WM-1  
PDR  
Return to  
NStill  
623-SS

SUBJECT: MEETING ON SITE CHARACTERIZATION TESTS AND  
INFORMATION NEEDS FOR LICENSE APPLICATION

Attached for you information is a report which summarizes the major points of discussion and agreements for the subject meeting held on April 13, 14 and 15, 1982.

\*FIGURE 12. Breakout Station Concept.

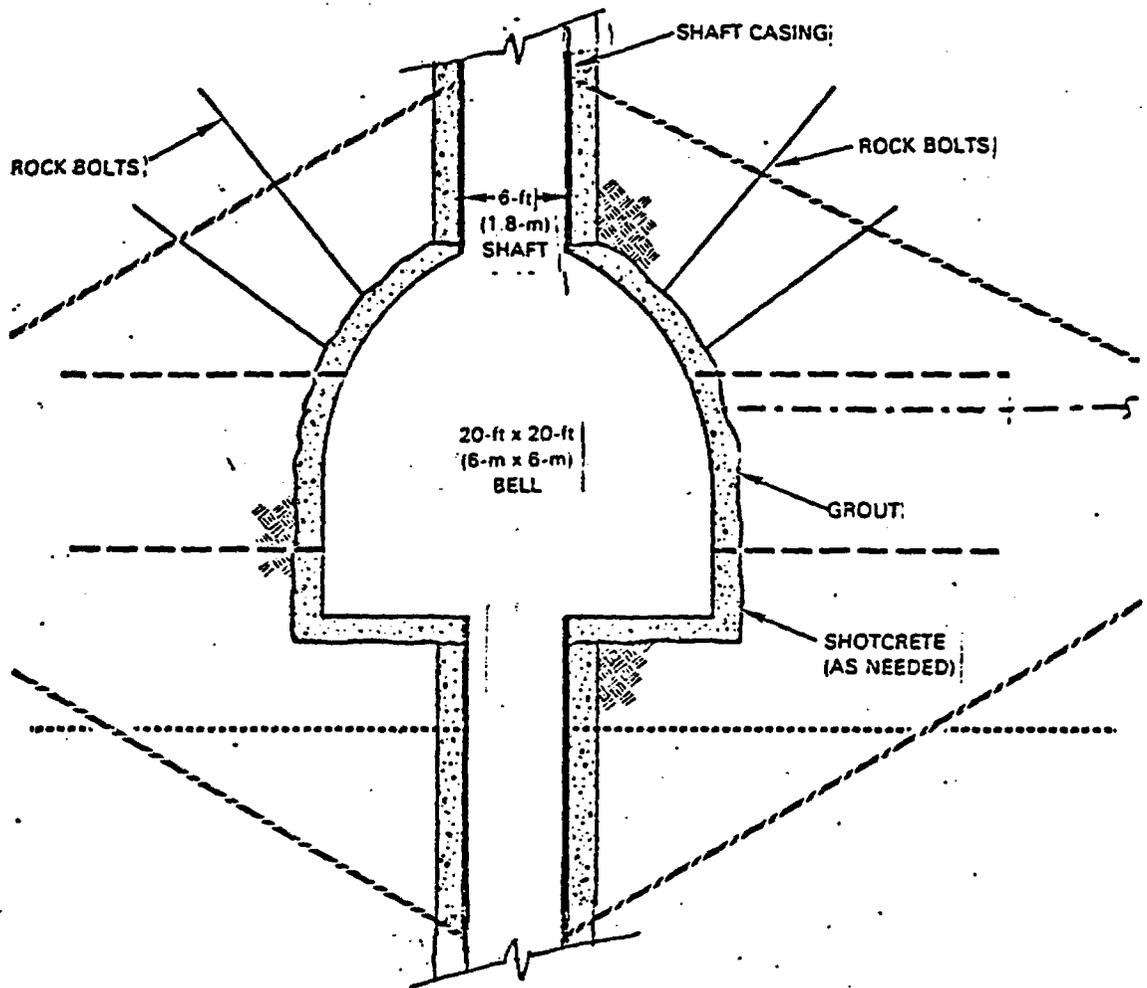
Figure 12\* suggests no hydrological testing - seems difficult to believe: a variety of flow tests are

Bell surface should be mapped in detail.

Figure 12\* states doorstopper tests: 8 @ 20' does this mean or imply multiple measurements up to 20' or point measurements at 20' and 50' only - the former would be preferable.
